ADDENDUM No. 4

**Walnut Street Bridge Repair and Rehabilitation
TDOT PIN: 128099.00
Federal Project Number: STP-M-9202(134)
State Project Number: 33LPLM-F3-229
Chattanooga Department of Public Works**

This Addendum #4, is being issued to provide:

1. Revised Special Provision SP-7 (Schedule)
2. Added Special Provision SP-8 (Guarantees and Warranties)
3. Revised Bid Item Form
4. Revised plan sheets 2, 4,4A, 4C,13, and E-0.3
5. Remainder of Questions and Answers

BRIDGE GENERAL
NOTES (4 OF 4)

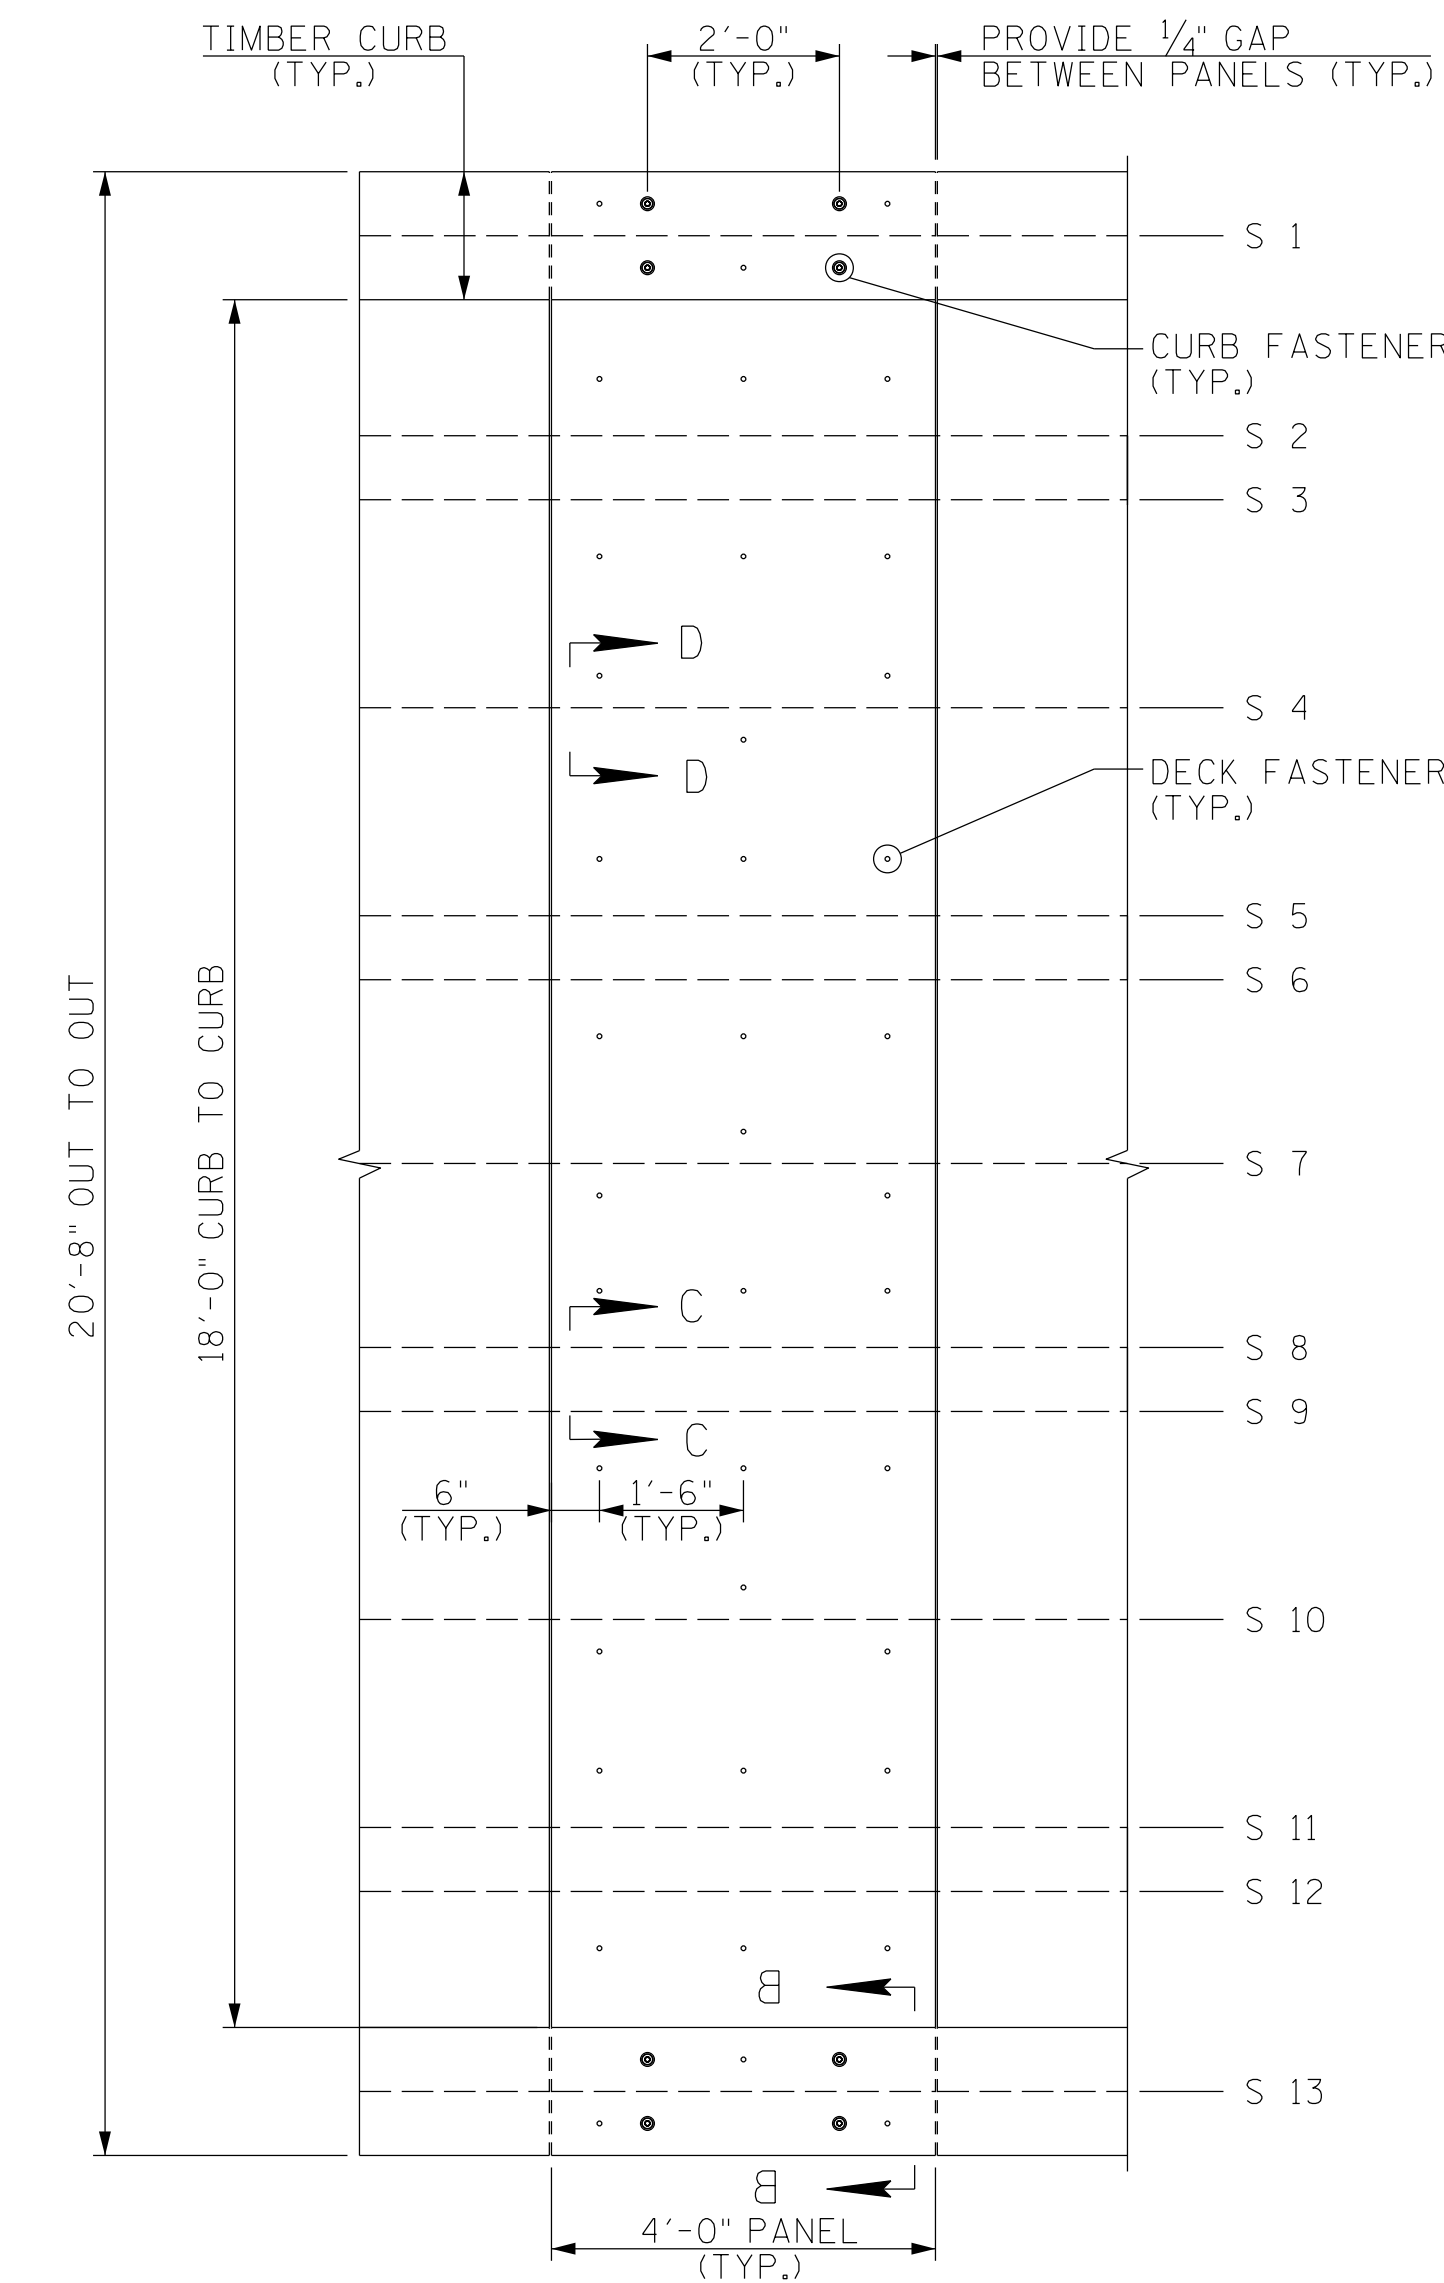
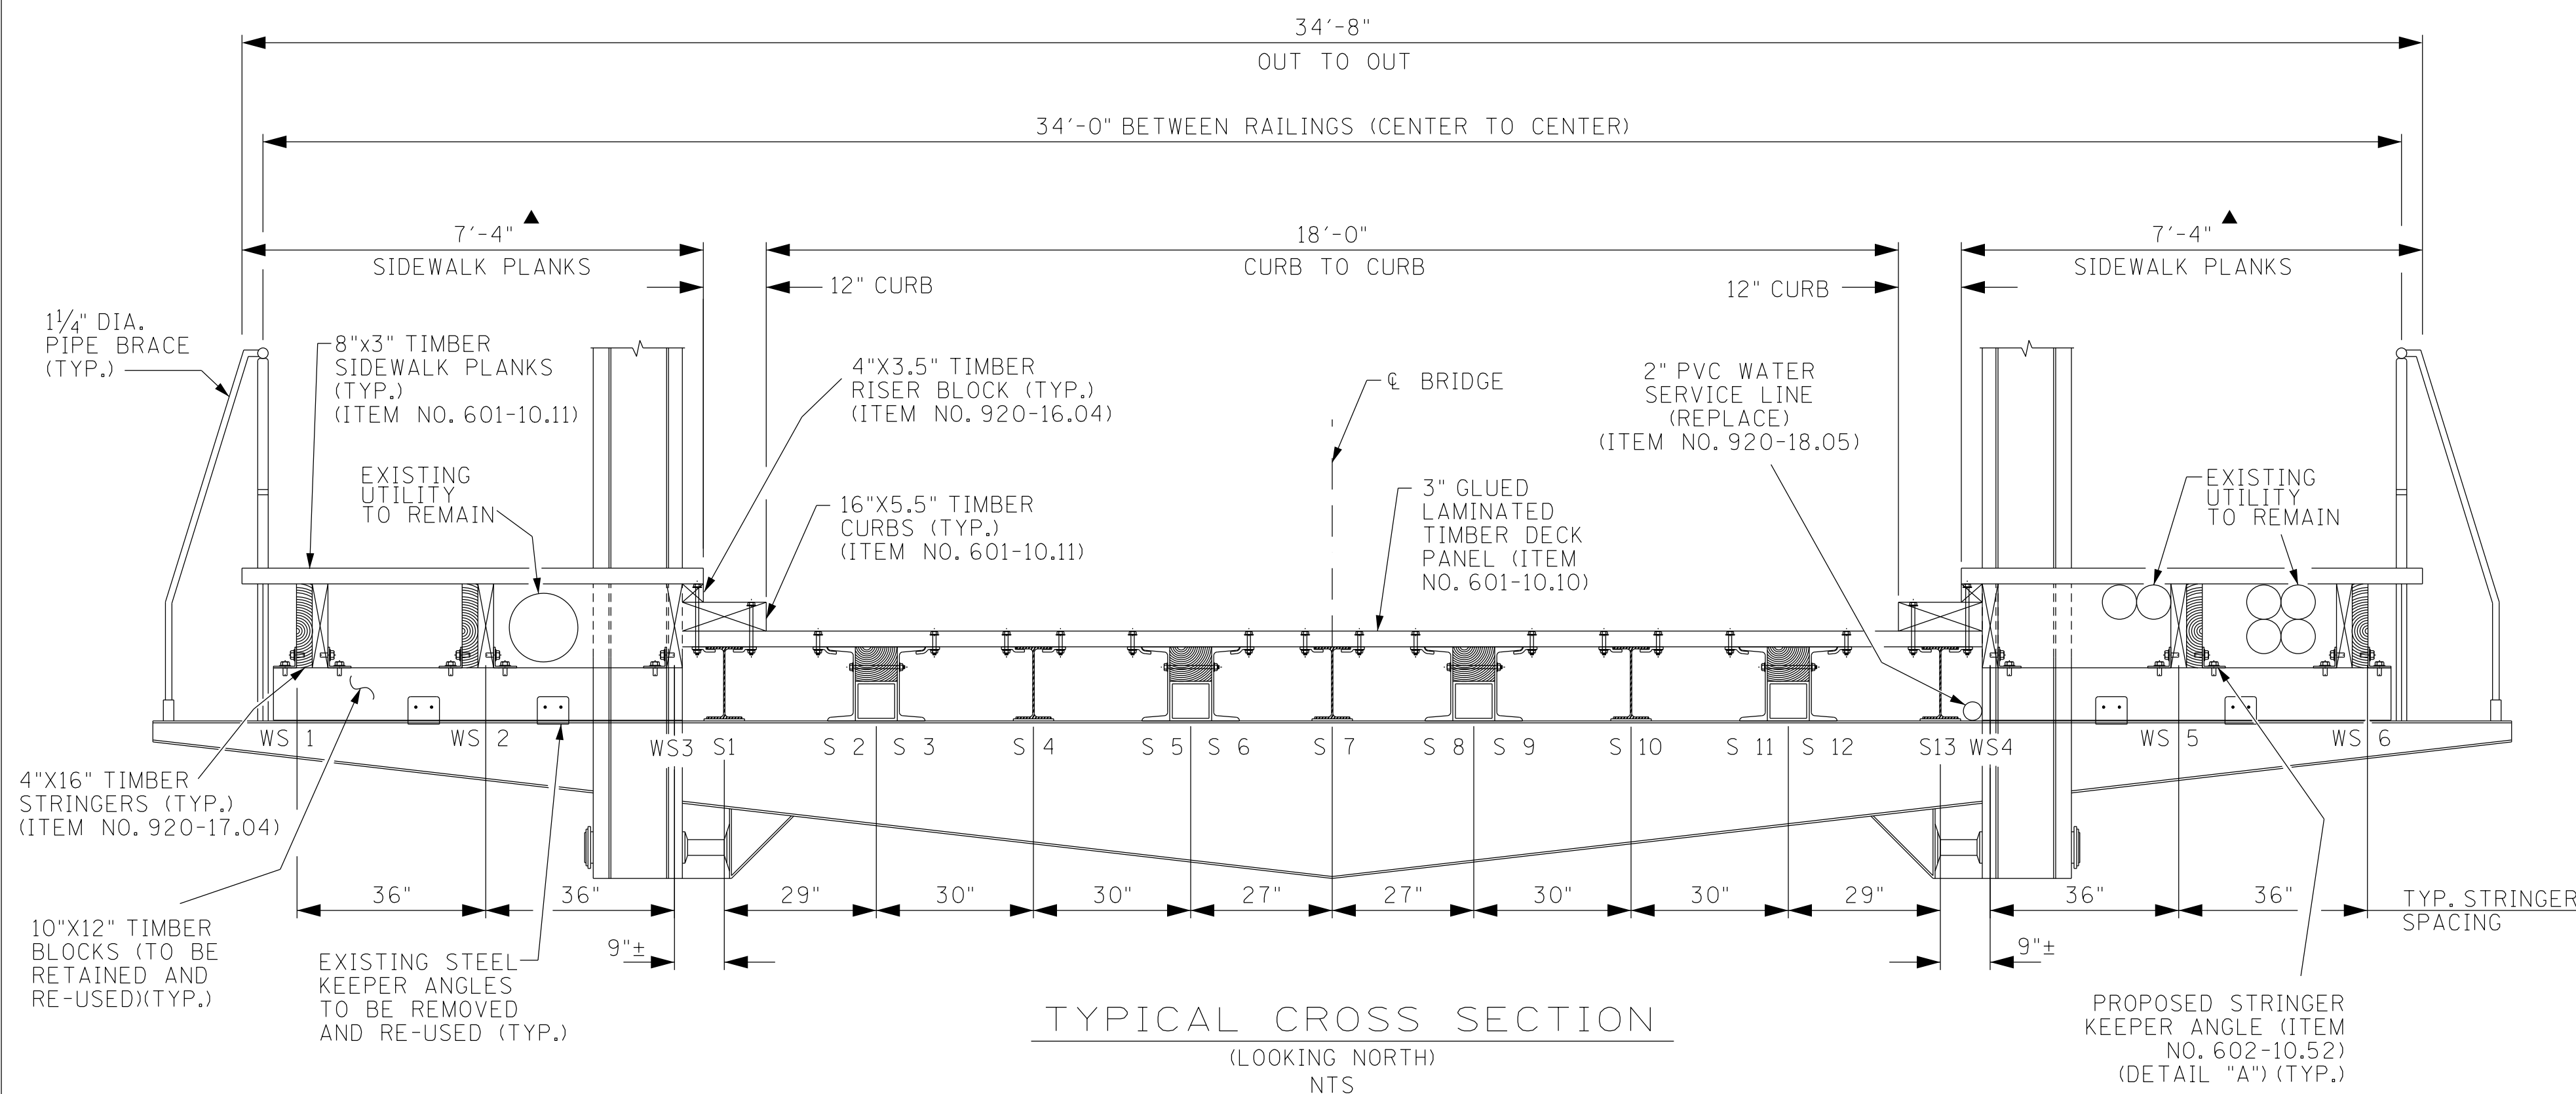
Sheet 4c note 87 states the waterline contains asbestos. Will it require abatement and removal by the contractor?	There is no removal of the asbestos waterline but contractor shall coordinate with and allow the Tennessee American Water Company contractor access and time to paint the waterline and replace bearing pads
Who performs and pays for ultrasonic, magnetic particle, and radiographic testing?	The Contractor.
Can the owner provide the value of the electrical service fee referenced on sheet E0.3?	Utility contact information has been provided.
What does item 714-25.02 and 714-25.03 include? Can the owner provide the value of any third party fees?	See footnotes in plans. Utility contact information has been provided.
Can the owner provide the value of the fees required under item 920-17.05?	Permit guidance was given in addendum 3
If third party fees the contractor is directed to include in their bid increase from those provided at bid time will the contractor receive compensation for the price increase?	No

- (87) THE EXISTING WATERLINE THAT BEGINS ON THE SOUTH END OF THE BRIDGE AND RUNS NORTH UNDERNEATH THE WESTERN EDGE OF THE SIDEWALK PORTION OF THE DECK SHALL REMAIN IN PLACE. IT SHOULD BE NOTED THAT THE WATERLINE HAS BEEN IDENTIFIED AS AN ASBESTOS-CONTAINING MATERIAL (ACM), AND IT SHALL BE THE RESPONSIBILITY OF THE CONTRACTOR TO FOLLOW ALL ABATEMENT REQUIREMENTS AS OUTLINED IN SPECIAL PROVISION SP202ACM AND THE NOTES ON SHEET 2C. FOR COATING OPERATIONS AT OR NEAR THE WATERLINE, THE CONTRACTOR SHALL CEASE BLASTING WITHIN 6 INCHES OF THE EXISTING WATERLINE AND EMPLOY A CLEANING METHOD IN ACCORDANCE WITH SECTION 603.05(B.1) OF THE STANDARD SPECIFICATIONS. HAND (SSPC-SP 2) OR POWER (SSPC-SP 3) TOOL CLEANING SHALL REMOVE ALL RUST, SCALE, LOOSE PAINT, AND DIRT. FOR ABRASIVE BLASTING IN CLOSE PROXIMITY TO THE WATERLINE, THE CONTRACTOR SHALL UTILIZE A SHIELDING METHOD TO PROTECT THE WATERLINE FROM BLASTING MEDIA, AND THE SHIELDING METHODOLOGY SHALL BE OUTLINED IN THE CONTRACTOR'S UTILITY PROTECTION

PLAN, AS DESCRIBED IN NOTE 7 ON SHEET 4. THE COST FOR THIS WORK WILL BE INCLUDED IN PAY ITEM 603-02.01 REPAINTING EXISTING STEEL STRUCTURES (WALNUT ST BRIDGE), LS.
